Product Advisory (PA)

Subject: Addition of full tray packaging for MCU products

SAG-B-24-0001
PC-MCU-A026A/E

Example of interior label of full tray packing

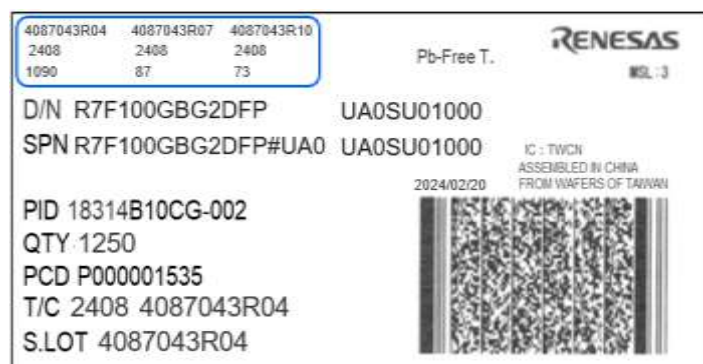
Renesas will add full tray packaging to MCU products in addition to fractional and full carton. The standard shipping packaging using Renesas trays is a full carton (complete packaging). However, if the customer's order quantity is less than a full carton, we will change it to the full tray that will be added this time. Renesas plan to discontinue production of fractional tray packaging in the future. Regarding full tray production lot management, up to three production lots may be combined.

Cases printed in the upper left area of the interior label

Cases not printed in the upper left area of the interior label
